INFORMATION BULLETIN NO. 112

TO: CUSTOMERS WITH CHASSIS LIFT KITS FOR REMANUFACTURED ROOF BOLTERS ONLY

SUBJECT: TRAM CHAIN GUARD

TRAM CHAIN GUARD INSTALLATION KIT
for RR-II STYLE CHASSIS with LIFT KITS

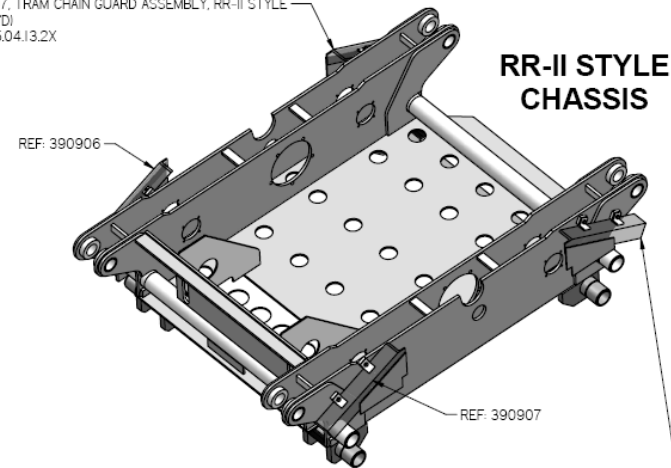
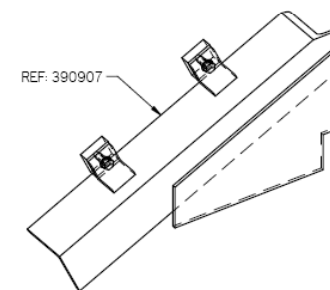
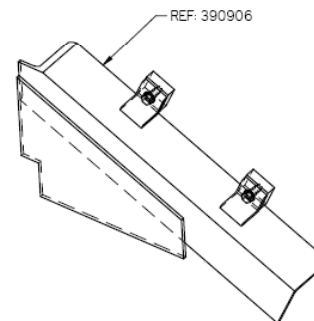
This particular chassis lift kit allows the ground clearance of the machine to be increased by adding axle tubes below the bottom plate of the chassis. Longer tram chains are connected to the sprockets. This modification of the machine results in more exposed drive chain. The standard tram chain guard no longer provides coverage of the tram chains when the chassis lift kit is installed. The chassis lift kit requires a tram chain guard kit, Part No. 418523 for RRII-Style Chassis, or Part no. 418521 for DDO-Style Chassis. The kit includes four guards, instructions for installation and all the mounting hardware necessary. Note; welding of tapped mounting bosses is necessary.

In order to prevent the possibility of any future injuries of this nature, Fletcher is providing every machine owner who has had a machine retrofitted with a Fletcher chassis lift kit a tram chain guard kit **FREE OF CHARGE.**

390907, TRAM CHAIN GUARD ASSEMBLY, RR-II STYLE
(2-RE0D)
DWG:45.04.13.2X

390906, TRAM CHAIN GUARD ASSEMBLY, RR-II STYLE
(2-RE0D)
DWG:45.04.13.2X
